CAROLINA POWER & LIGHT CO.  
SHEARON HARRIS NUCLEAR P.P.  
UNIT NO. 1  
CONTROL WIRING DIAGRAM  
STEAM GEN. B ATMOSPHERIC RELIEF VALVE 2MS-P19-SB-1

CAR 2166  
B-401  
SHEET 1255

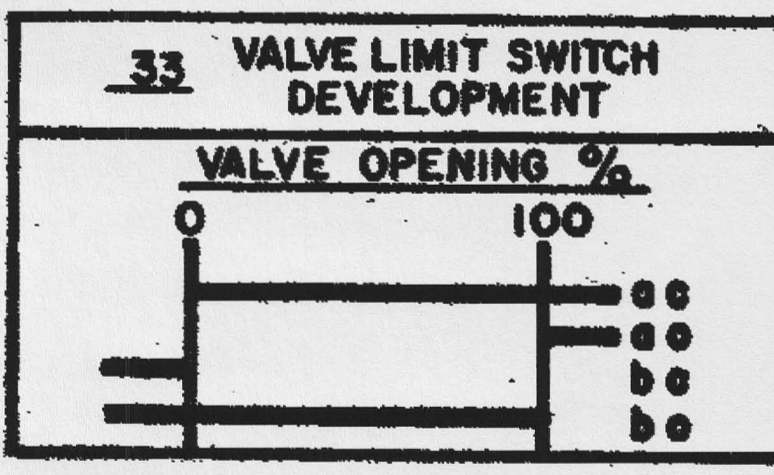
Change to Instrument  
Bus SI, SII, or SIV.
